Platteville Aquifer Northern  
Area Feasibility Study for the  
Reilly Tar & Chemical  
Corporation N.P.L. Site, St.  
Louis Park, Minnesota

**Document Number 1620-013-300**

March 14, 1994

The balance of this letter responds to the various issues identified in the Agency letter of December 23. To assist the reader, the Agency's comments/issues are printed in bold type and the City's response is presented in normal type.

Figure 1  
Site Location  
St. Louis Park, MN

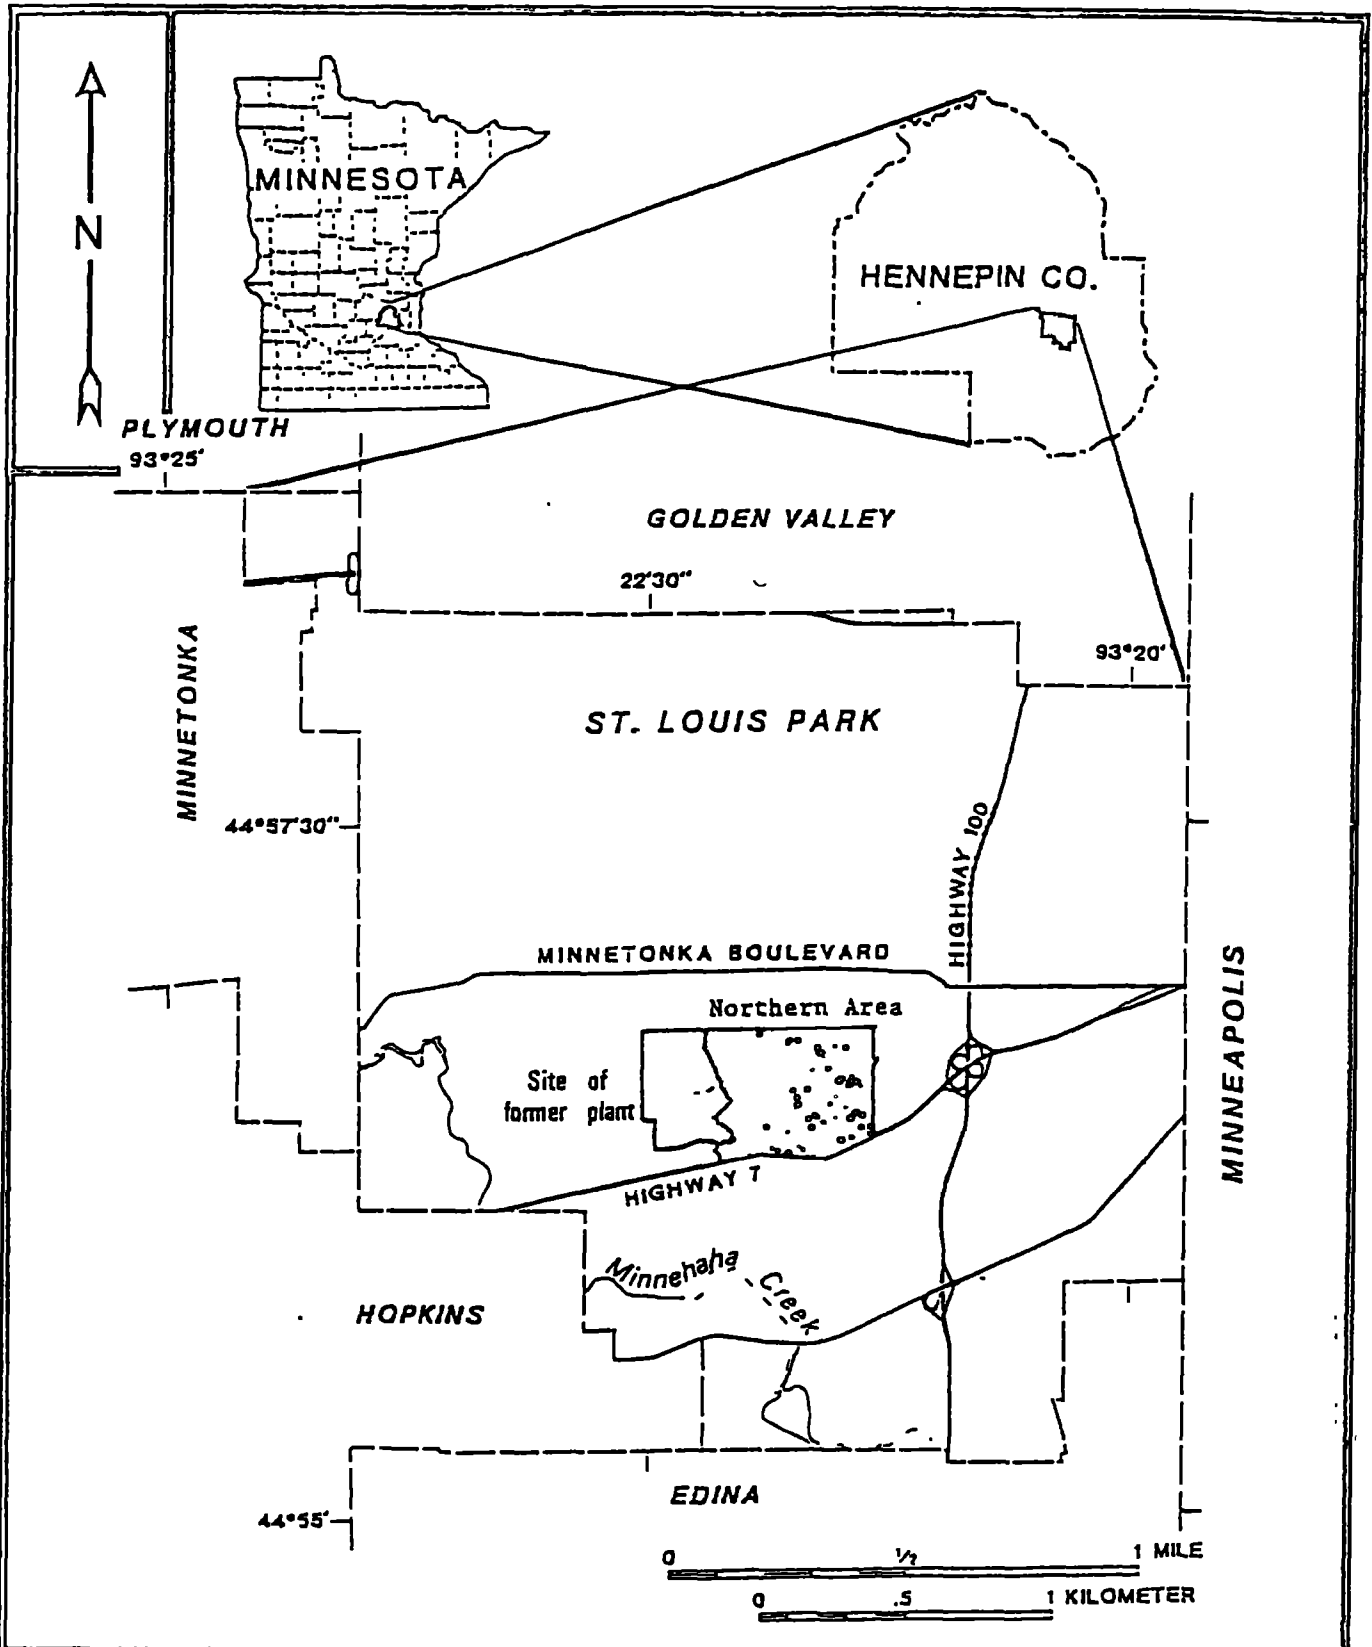
**Background and Site History, Figure 1, Site Location is missing from the Report.**

Figure 1 is now included in the report.
